LAKE COUNTY PLANNING DEPARTMENT

June 11, 2009

Borchers of Finley Point Homeowners' Association:

Addendum - Borchers of Finley Point Homeowners' Association

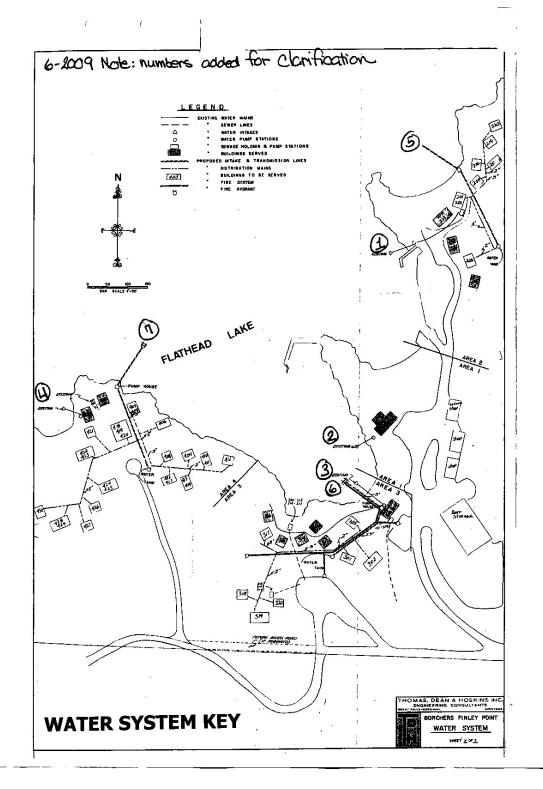
At the time of the subdivision in 1977, there were at least four pre-existing lake water intakes: see 1, 2, 3, and 4 located on the map.

Approved subdivision plans identified three new lake water intakes to serve the homesites that would be constructed: see 5, 6, and 7 located on the map. The pre-existing water systems would continue to serve the pre-existing homes until the systems failed at which time connection to a new system would require review and approval by MDEQ.

The approved subdivision plans were for one community lake water system and two multi-user lake water systems. It appears at least the community system required the water be filtered and chlorinated. It appears all systems were to provide storage tanks.
